**Transmission Line
Project
Wyoming**

Final Environmental
Impact Statement

US Department of Energy
1984

Thermopolis-Alcova-Casper Electrical Transmission Project

Revised Figure S.1

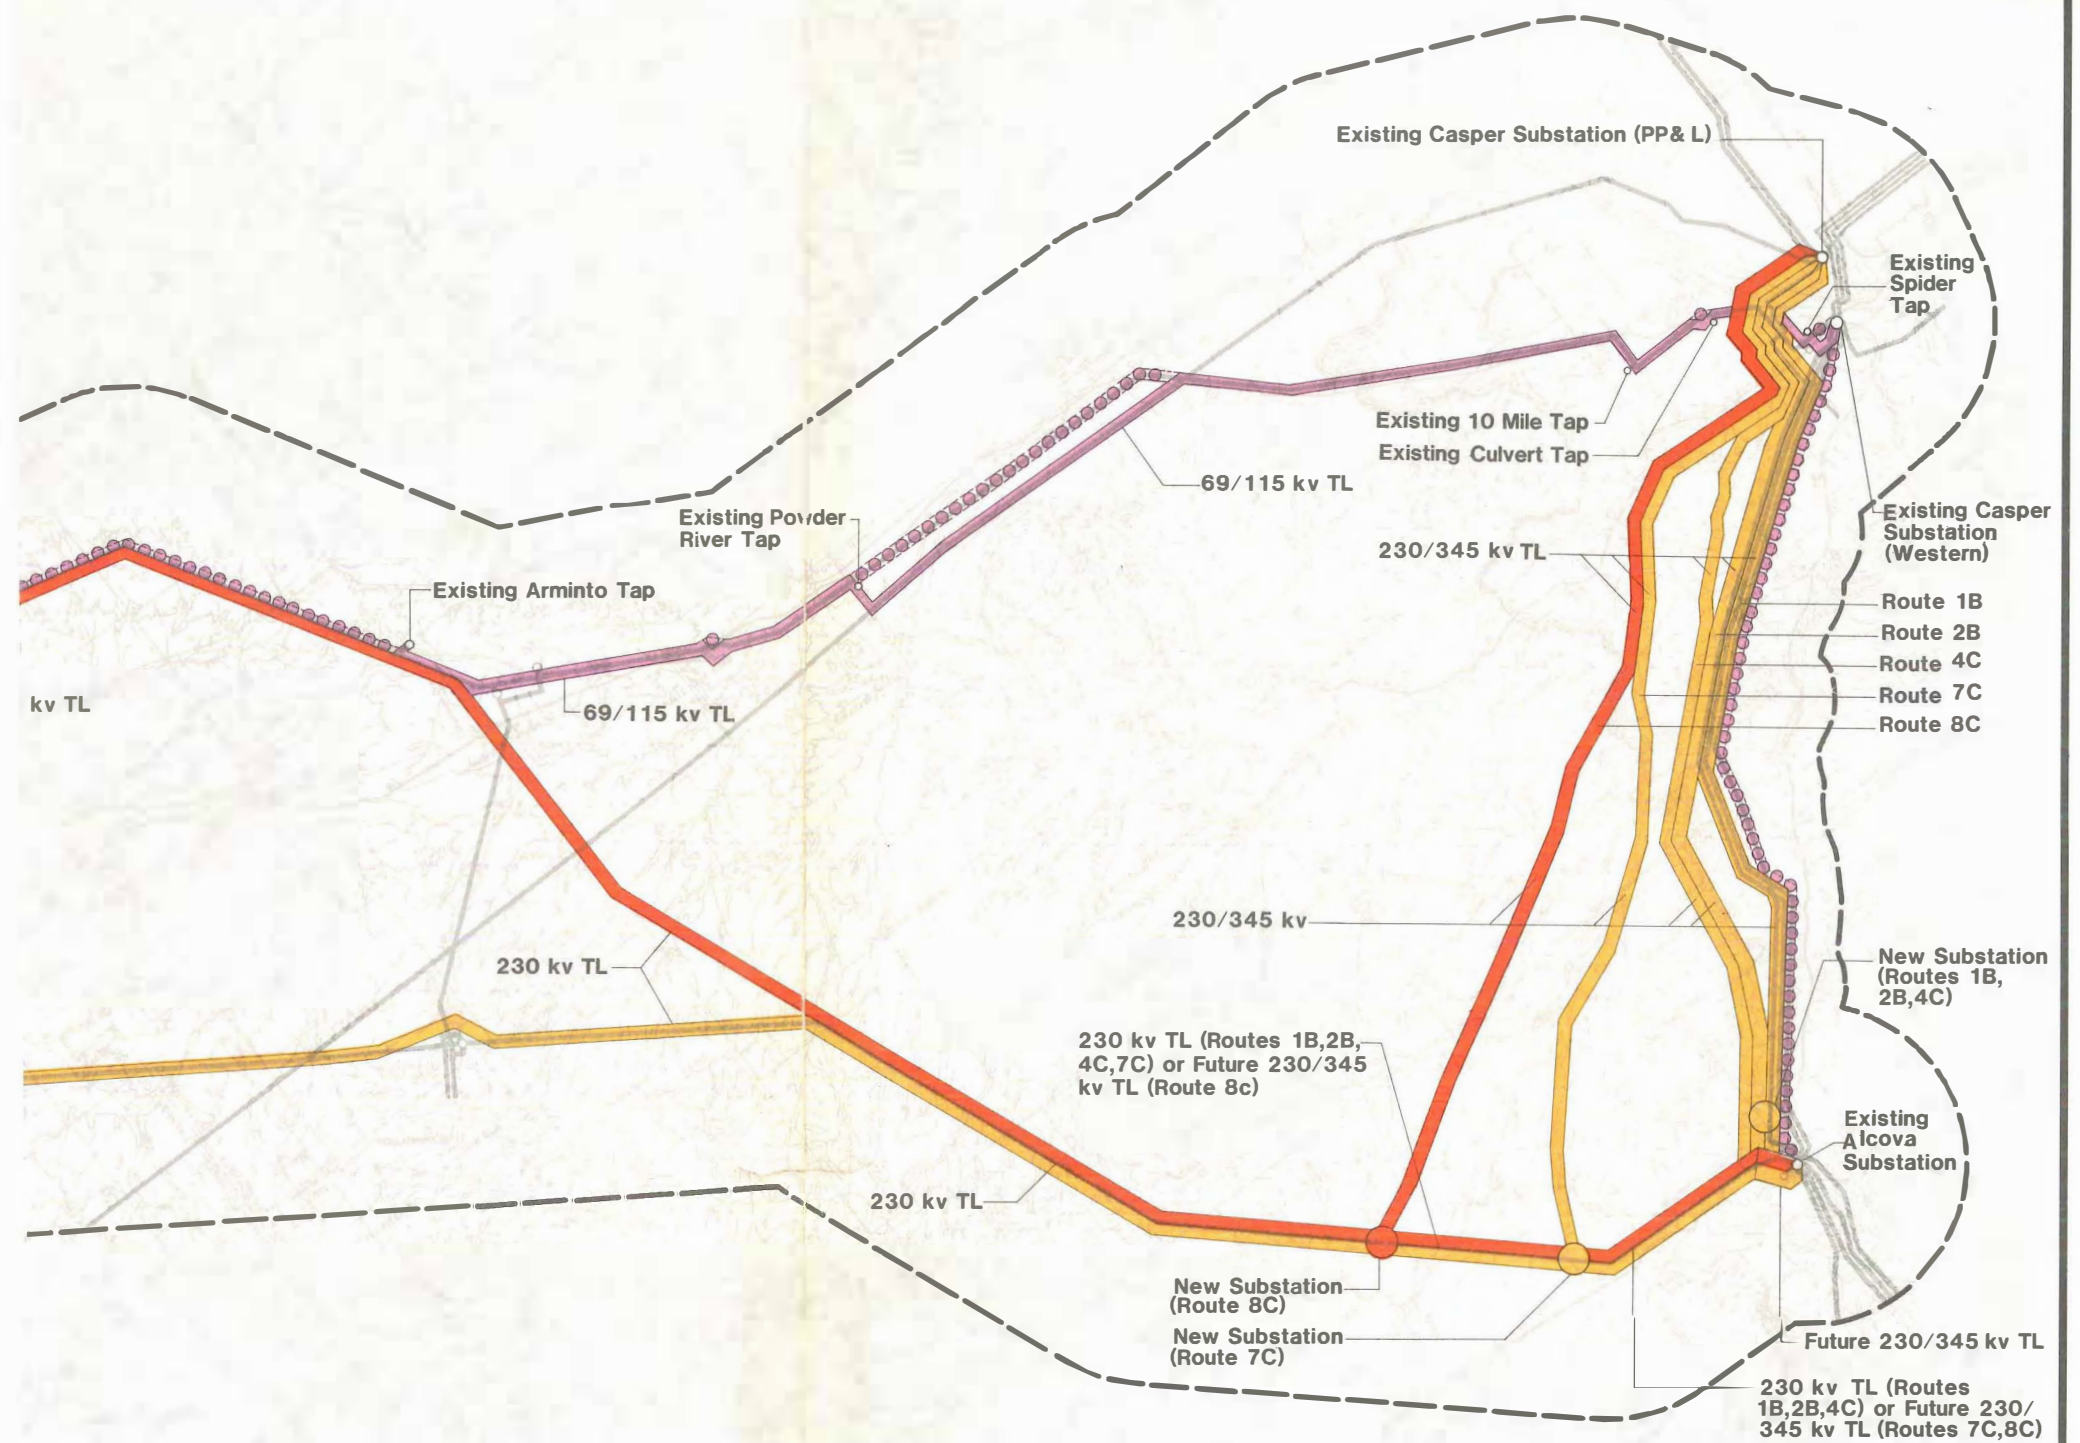
The main substantive changes between the DEIS and the FEIS are the abandonment of the North Platte River Corridor as the preferred route between Alcova and Casper (due to a newly adopted BLM policy to drop that area as a designated utility corridor), and a reconsideration of some impact values due to: the above policy change, new concerns relative to wildlife, and the fact that committed mitigation measures are now able to be more precisely defined.

All the elements of the proposed action, as described above, are shown on Figure S.2 (Revised) in this FEIS.

Structure Types

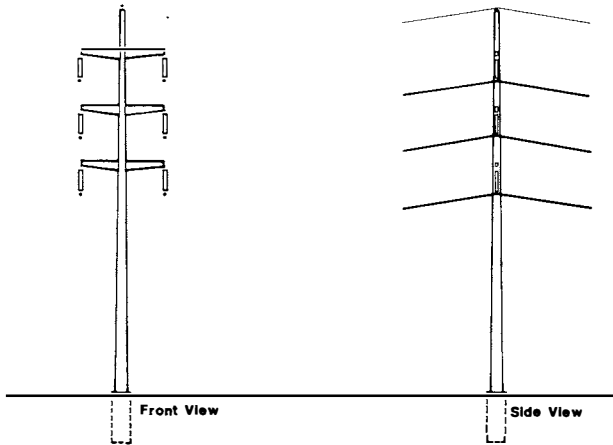
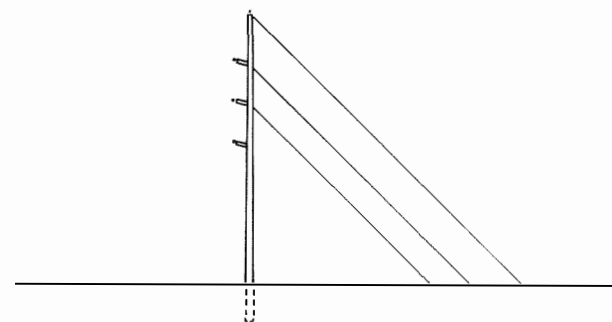
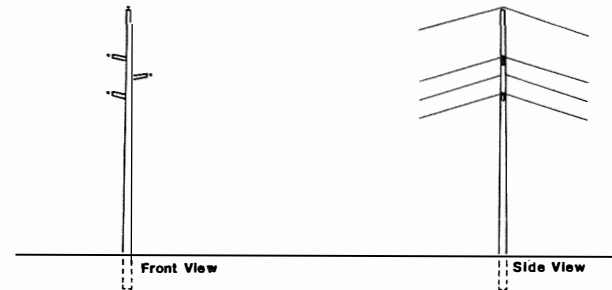
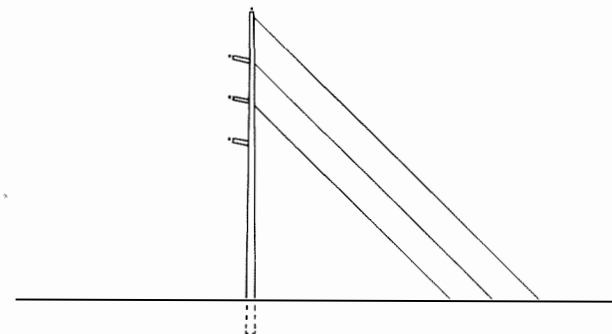
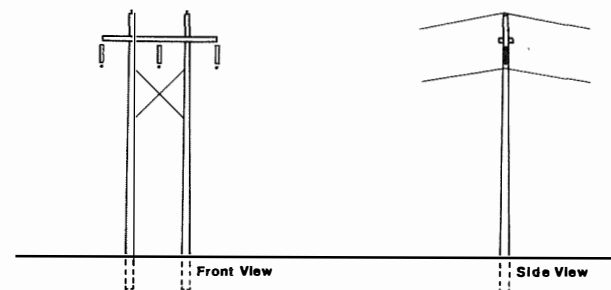
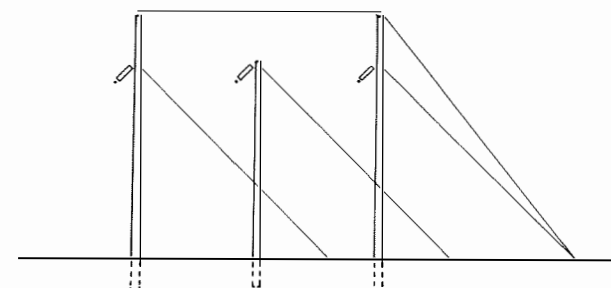
Figure 3.2 in the DEIS, ROW Conditions and Structure Types, shows the full range of alternative structure types that were originally under consideration for use in each segment of the preferred and primary alternative routes of the proposed system (including the relatively minor, lower voltage actions). Cost studies have now been completed by Western and a much more limited range of structure types, or in some cases a single type, can now be defined for the elements of the

project. These structure types are illustrated on Figures 3.3 and 3.4 (Revised) in this FEIS. The candidate structure type for each element of the project (preferred routes) are as follows:

This structure type is the standard design for 34.5-kV lines. It has the advantages of economy, simplicity, and unobtrusiveness. It will be used for the short 34.5-kV line between Bridger Substation and Bridger Pump Substation (Type A, Figure 3.3, revised).

This type could also be used for the project's 69/115-kV lines in congested urban areas where its narrower required width of ROW (as compared to the more usual H-frame type) may be easier to obtain. Similarly, it may be used in certain locations where the line skirts the edge of a cultivated area, to minimize impacts to agricultural land uses. It should be noted that the span is very short with this type, and structures occur approximately twice as frequently as with wood H-frame (Type B, Figure 3.3, revised).

Structure Type
 230 KV (1 cct.)
Steel H-Frame

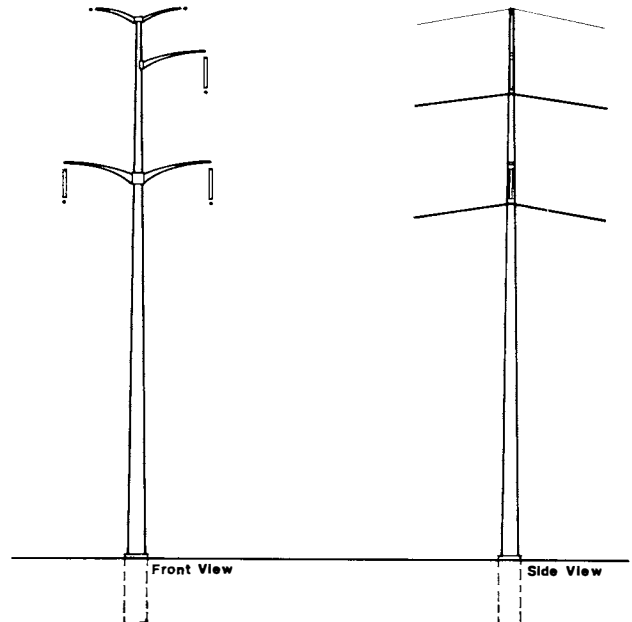
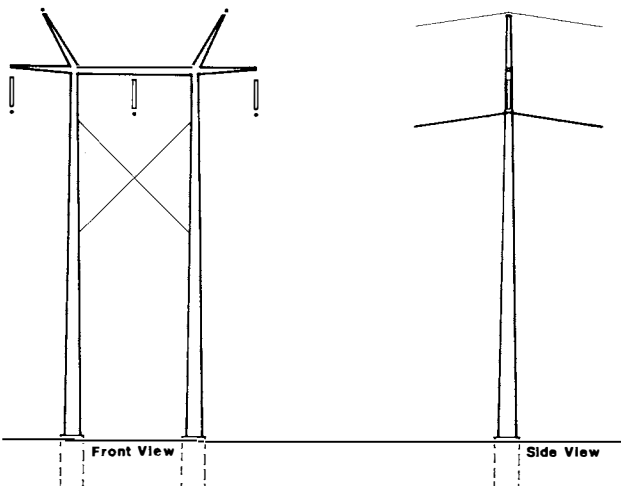
- o Thermopolis-Alcova 230-kV line
 - Type H revised
 - Type J revised (J will definitely be used at the crossing of the Bighorn River south of Thermopolis)
- o Alcova-Casper 230/345-kV line
 - Type H revised (a special horizontal circuit configuration type will be used at the crossing of Emigrant Gap Ridge, west of Casper. This may be a lattice steel type)
- o Arminto-Casper 69/115-kV line
 - Type B
 - Type C
 - Type E (used only in one segment, about one-half mile long, immediately southwest of Western's Casper Substation with one circuit left empty)
- o Spar line from New Lost Cabin Tap to Existing Lost Cabin Tap
 - Type B
 - Type C
- o Bridger Substation to Bridger Pump Substation
 - Type A

This structure type (Types E, H, and J, Figure 3.4, revised) is traditionally used where visual quality is important and the line is close to the viewers as, for example, in urban areas, or when a line is adjacent to a recreation area.

Type E is sometimes used for 115-kV lines and is common in the situations described above. It is proposed for a short segment of double circuit 69/115-kV line in Casper. Type J (revised) is proposed for most of the preferred 230-kV route between Thermopolis and Alcova. Type H (revised) is proposed for parts of the Thermopolis-Alcova preferred route and for essentially all of the Alcova-Casper preferred route.

Link 2a

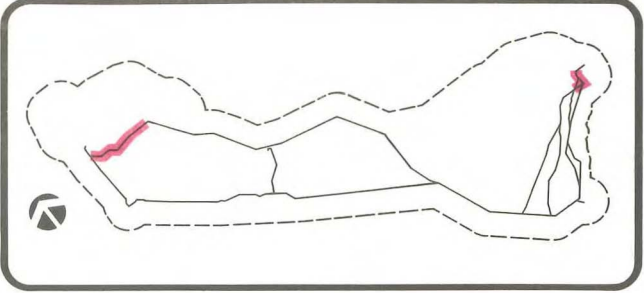
Note: A revised version of Link Map 2a, showing an adjustment to the route, appears in this FEIS.

The alternative, as shown on Link Map 2a (Revised) in this FEIS, was adjusted to avoid a proposed center pivot irrigated area. This adjustment does not appear to increase any other impacts.

Subroute C

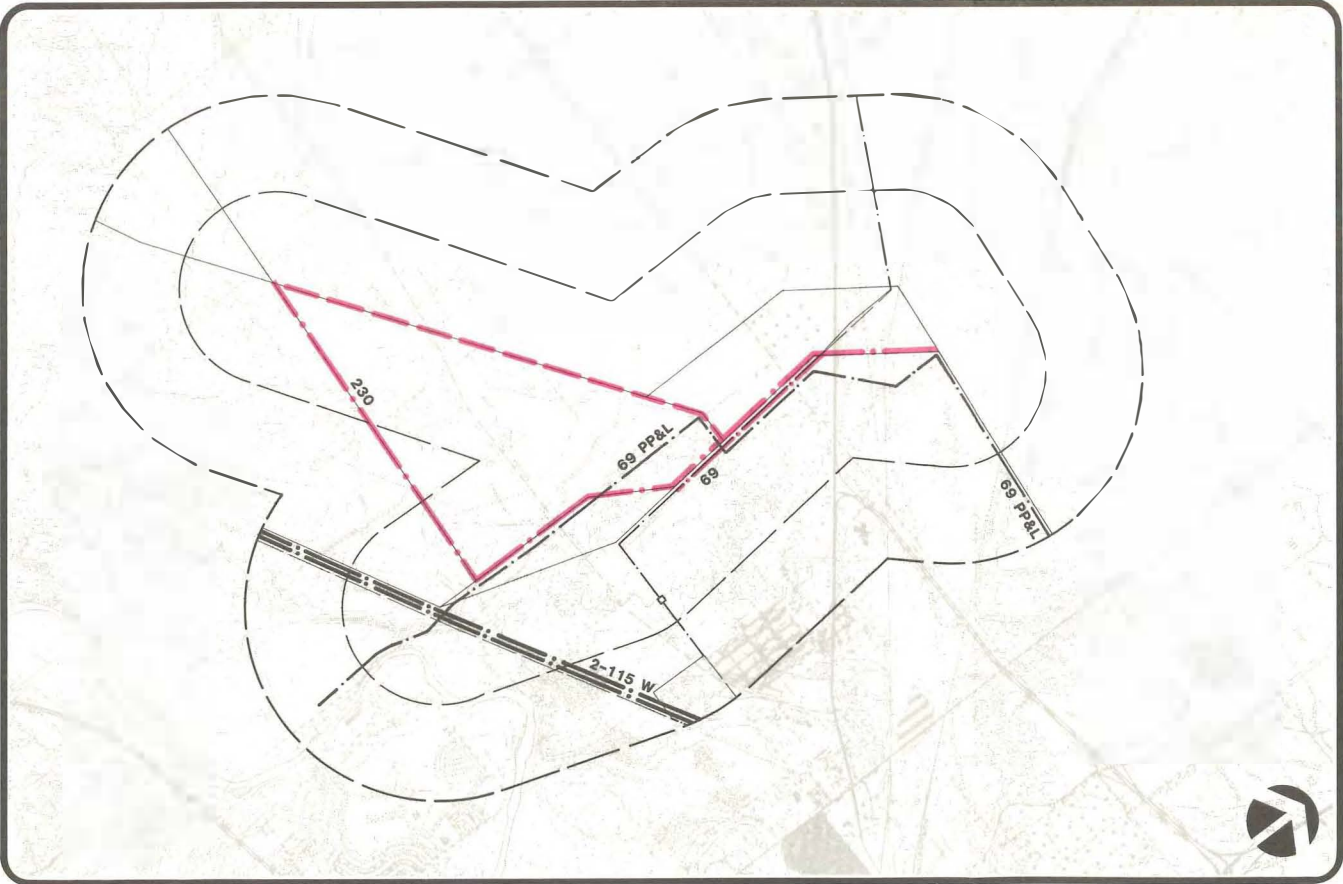
Note: A revised version of Link Map Subroute C, showing an adjustment to the route, appears in this FEIS. This new version of Subroute C consists of: a new link (an extension east of Link 25), Link 29, Link 31, and Link 35/37.

The new preferred alternative and Alternatives 7C and 4C now enter Casper by a route that differs from the one shown in the DEIS. This modified route is shown on Link Map Subroute C (Revised) in this FEIS. The change consists of extending the route east from the east end of Link 25 until it intersects the remaining primary alternative routes (1B and 2B). The new route is slightly longer, but makes better use of existing ROW and will fit better into future land use patterns on the southwest fringe of Casper.
